From: [Miller, Ed](#)
To: ["RILEY, Jim"](#)
Subject: Comments on Dam Failure White Paper from Public Meeting
Date: Friday, October 26, 2012 3:14:00 PM
Attachments: [Dam Failure Rev D.docx.docx.docx](#)

POST-FUKUSHIMA NEAR-TERM TASK FORCE RECOMMENDATION 2.1

Supplemental Guidance for the Evaluation of Dam Failures

Figure 2 – Example Illustration of Dam Failure Evaluation Screening Approach (Method 4)

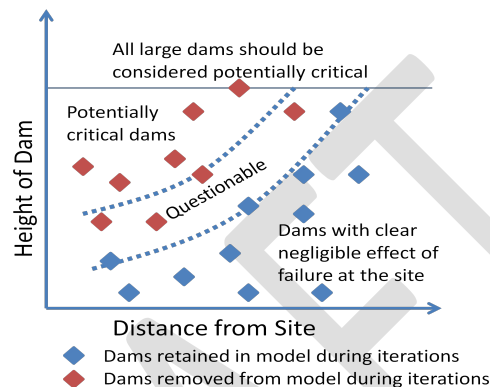
Comment [g18]: How do you account for uncertainty
 FFTF – The screening process is a conservative comparison to determine what dams can be excluded. It evaluates incremental effects; it does not develop an absolute value for flooding levels. Since this is intended to be a conservative high level comparison, uncertainties are not important to consider.

Discuss the use of the DSS-Wise tool developed by NCCHE for screening.

Comment [initials19]: FFTF – OK, later

Figure 3 - Approach to Hydrologic Failure Evaluation

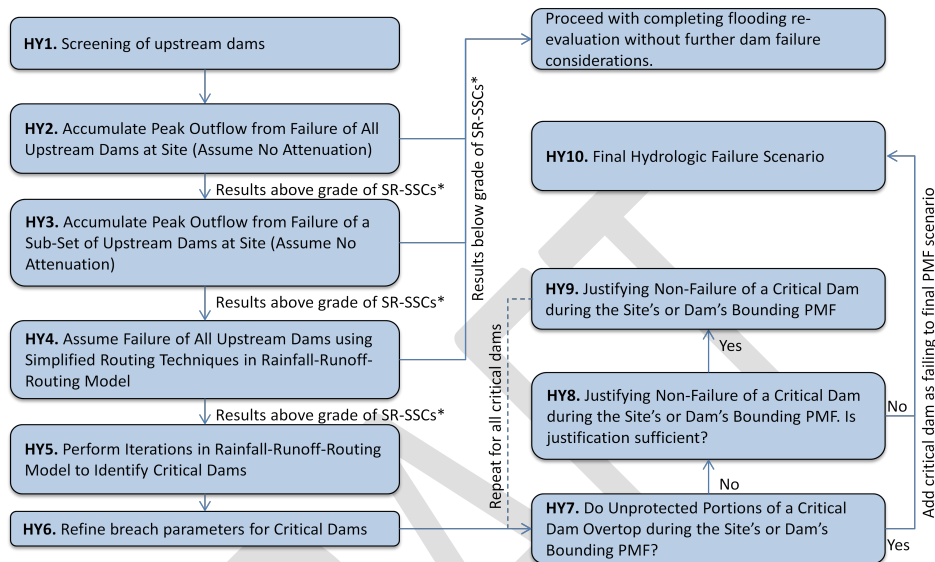
FFTF - Subset is intended to only apply to Step HY3. HY4 was updated in the chart and write-up to clarify.
 Clarify which dams are to be considered in each step
 FFTF – OK, see above
 Adjust wording to clarify the purpose of this process
 FFTF – OK, see above
 Clarify potential uses of the outputs of this section
 FFTF – Output is used to determine if you can proceed without further consideration of dam failure. Clarification will be added within the individual steps.
 More guidance on how to refine parameters
 FFTF – added reference to section 4.7 under step HY6.

Figure 8 – Distance/Height of Dam Plot

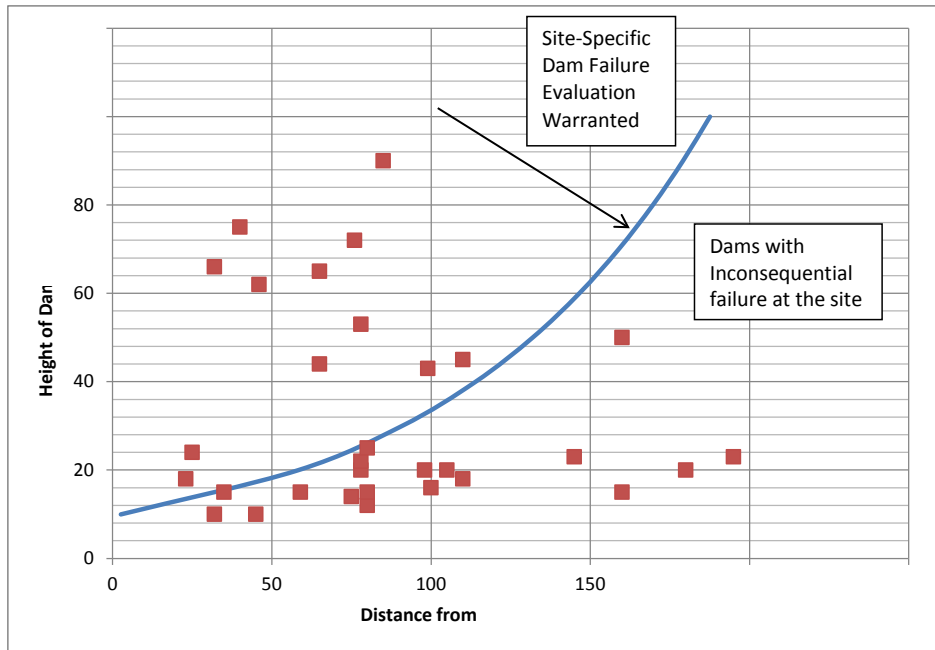
Comment [g47]: Possibly move to an appendix. FFTF – this appendix is being rewritten. Comments will be addressed with the revision
Describe limits of scope of applicability (downstream distance, dam height, etc...) and reflect limits in figure.

Comment [g50]: Needs further development to address this issue; define limits in example application of USBR equations.

Comment [g51]: Possibly move to an appendix.

Describe limits of scope of applicability (downstream distance, dam height, etc...) and reflect limits in figure.
